SERVICE TIPS

"EXPORT", CYBERNET 02A-PLL AM/FM/SSB CHASSIS

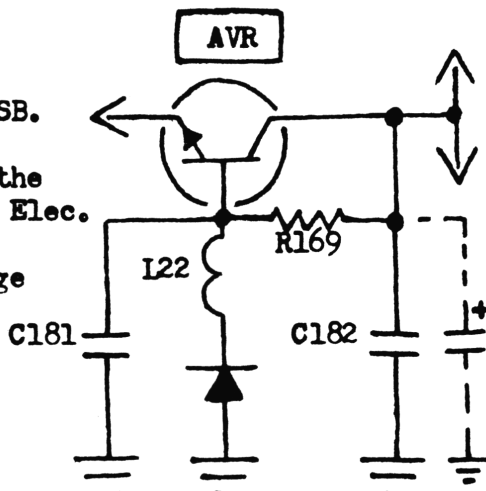
ALL UNITS THAT HAVE THE 2SC1969: CHANGE FINAL!.....Specified to SCB

The other big problem is in the AVR, (check your schematics for the right transistor, as is different marking in some chassis..) General Layout below.

Problem: Scratchy TX in SSB.

Note: in most units this is Q36, and a 2SD837 or 2SD1192 is usual transistor.

Replace with 2SC1307; adjust bias for 15ma; maximum.

Cure: Add C184 if not in the circuit. (470Mfd/16V Elec. Capacitor.

If problems persist: change the present Xstr to a 2SD839..

C184; ADD-470Mfd/16VDC, if not in unit. Observe correct polarity!
